SUBJECT: Campaign #88 -Ford® F53 LP. Brake Warning Indicator

INSTRUMENT CLUSTER BRAKE WARNING LAMP CIRCUIT REVISION

AFFECTED VEHICLES: CERTAIN 2000 THROUGH 2003 MODEL YEAR
F-53 CHASSIS VEHICLES

FIGURE 1

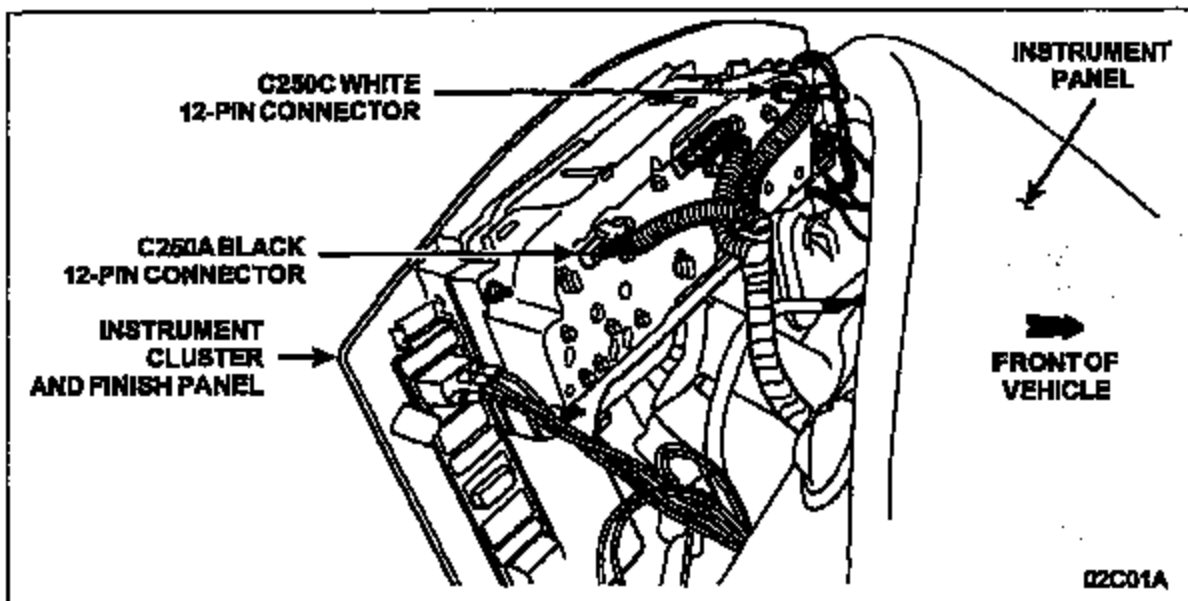
2. Disconnect the C250A (black 12-pin connector) and C250C (white 12-pin connector) instrument cluster electrical connectors. See Figure 1.

FIGURE 2

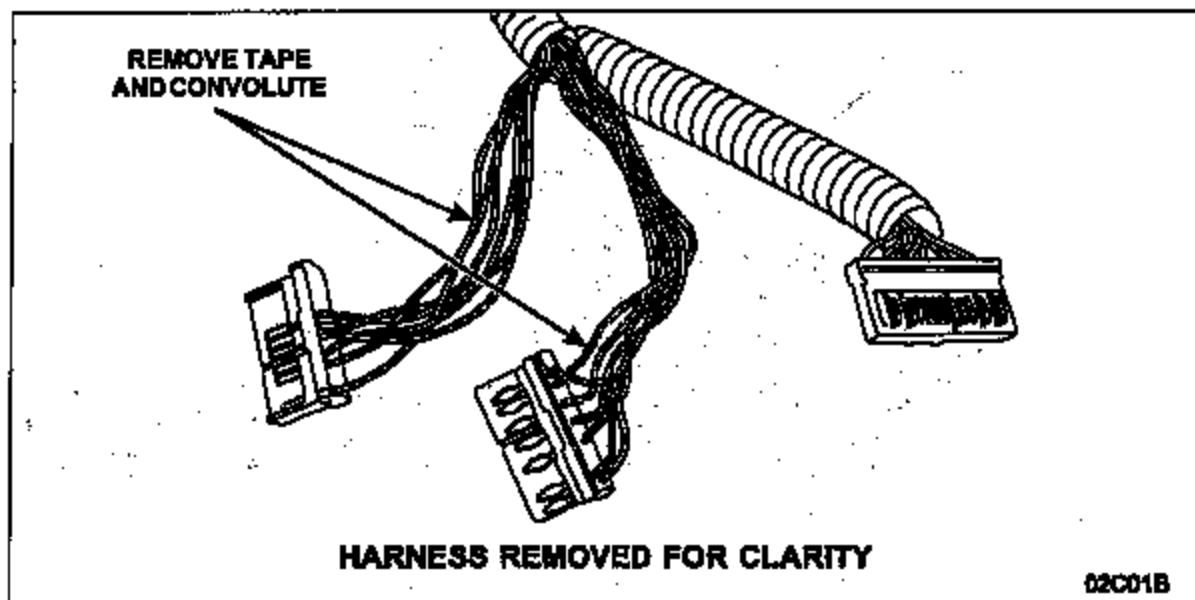
3. Remove the tape and the convolute from the C250A and C250C harnesses up to the point they join the main harness. Retain the convolute. It will be reinstalled. See Figure 2.

FIGURE 3

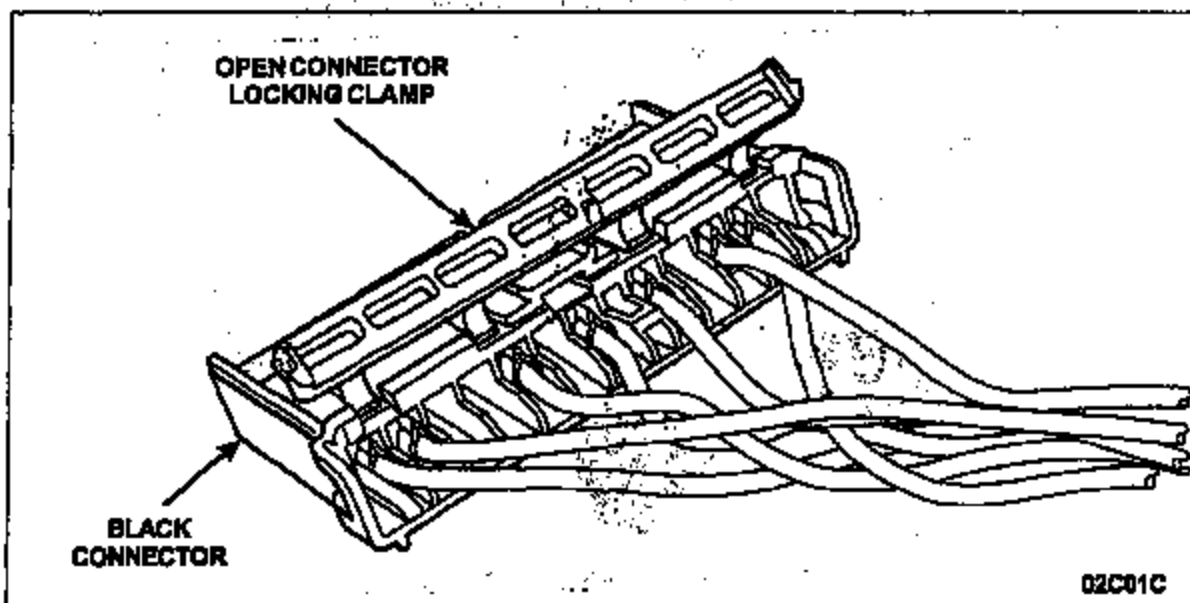
4. Open the black 12-pin connector locking clamp. See Figure 3.

FIGURE 4

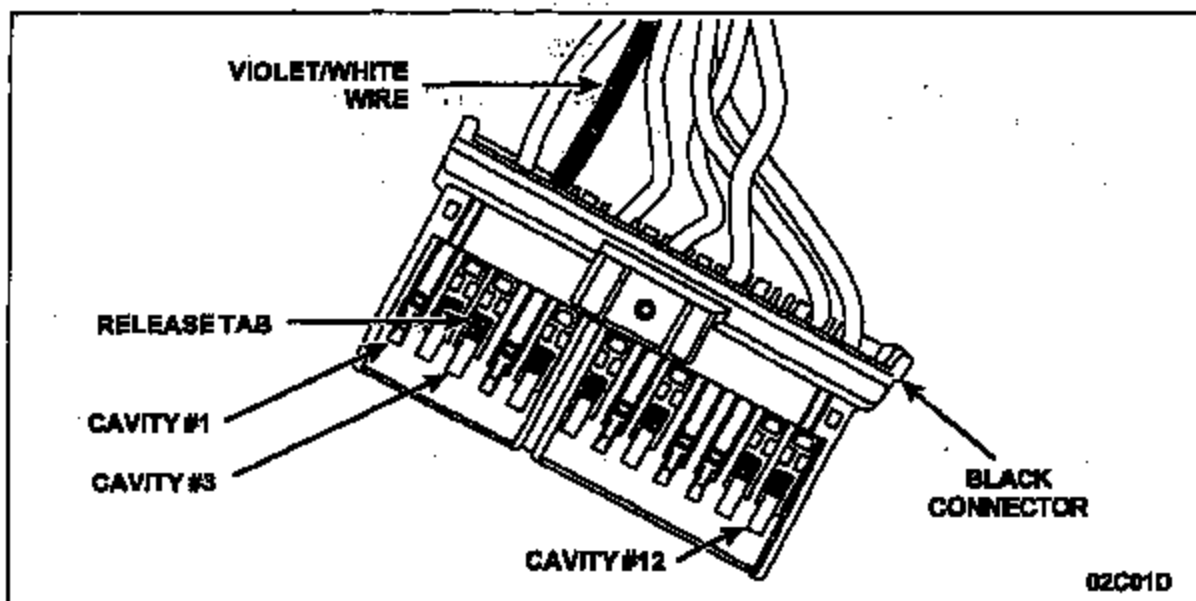
5. Remove the VIOLET/WHITE wire from cavity No. 3 by pushing the small release tab and pulling the wire out of the cavity. Then, close the locking clamp. See Figure 4.

FIGURE 5

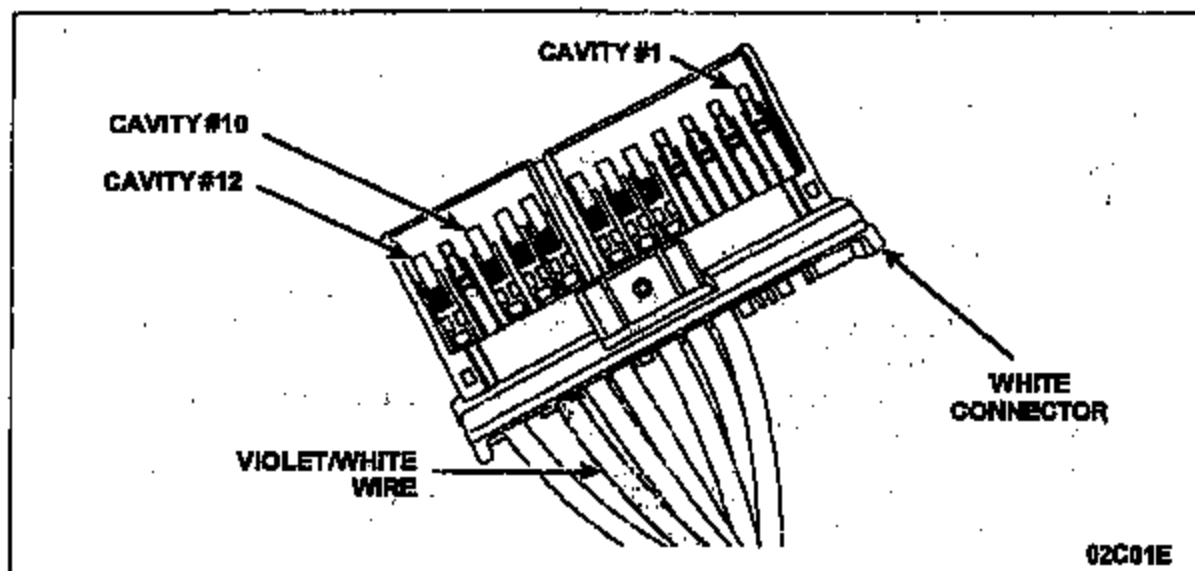
6. Open the white 12-pin connector locking clamp and install the VIOLET/WHITE wire into cavity No. 10. Pull the white wire with light force to make sure it is fully seated. Then, close the locking clamp. See Figure 5.

FIGURE 6

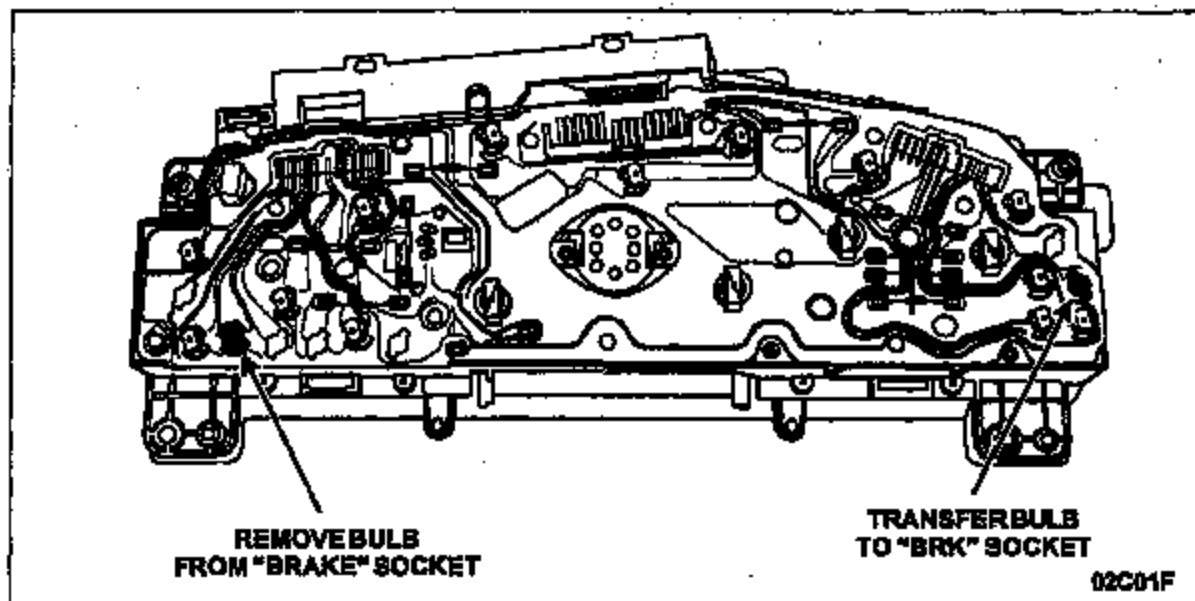
7. Install the convolute and retape both harnesses.
8. Remove the bulb from the "BRAKE" socket and transfer it to the vacant "BRK" socket located on the opposite side of the cluster. See Figure 6.
